Docket Number:	24-BSTD-03
Project Title:	2025 Energy Code Compliance Software, Manuals and Forms
TN #:	268349
Document Title:	IES VE T24 2025-1-0 Sensitivity Test Narrative
Description:	N/A
Filer:	RJ Wichert
Organization:	California Energy Commission
Submitter Role:	Commission Staff
Submission Date:	1/29/2026 10:10:43 AM
Docketed Date:	1/29/2026

Narrative for IES VE Title 24 2025.1.0 Sensitivity Tests

Figure 1: IESVE TES loop and ChWL

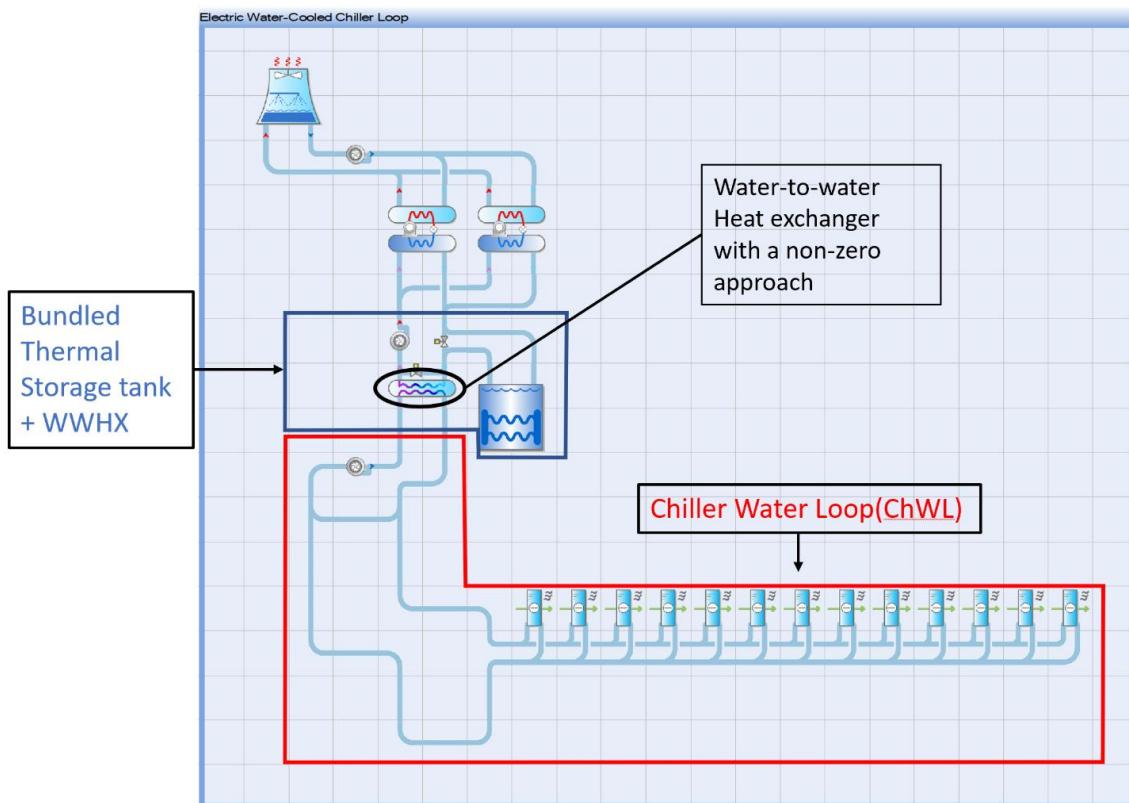
- CEC Comment: Higher TDV Energy in the TES model than the Baserun model.

The TES model in IESVE has a Water-to-water heat exchanger (WWHX) that transfers heat between the TES loop and the ChWL (see Figure 1 below). This heat exchanger is permanently coupled with the TES tank to avoid any potential mixing of water/glycol with water only; thus maintaining the heat transfer properties of water in the Chilled Water Loop. The WWHX has a non-zero approach temperature. i.e., there will always be a temperature drop in the WWHX. To account for this temperature drop, when the chiller is cooling the building, the chiller leaving water temperature needs to be lower than the required ChWL supply temperature (44°F) because it must first overcome the inefficiency of the WWHX.

However, the baseline model (400006) does not have a WWHX. As a result, the chiller water leaving temperature is 44°F.

Since the chillers in the TES model has to cool the water to a lower temperature (to account for the temperature drop in the WWHX) the chillers consume more energy than the baseline chiller. This has therefore been reflected in the output values of the model.

WWHX (no bypass), in the TES model 0418506, is causing a year-round inefficiency, especially during periods where the TES is not operational, because the WWHX cannot be bypassed. Baseline model 400006 has no WWHX; therefore the baseline is not penalized for the inherently inefficient WWHX.
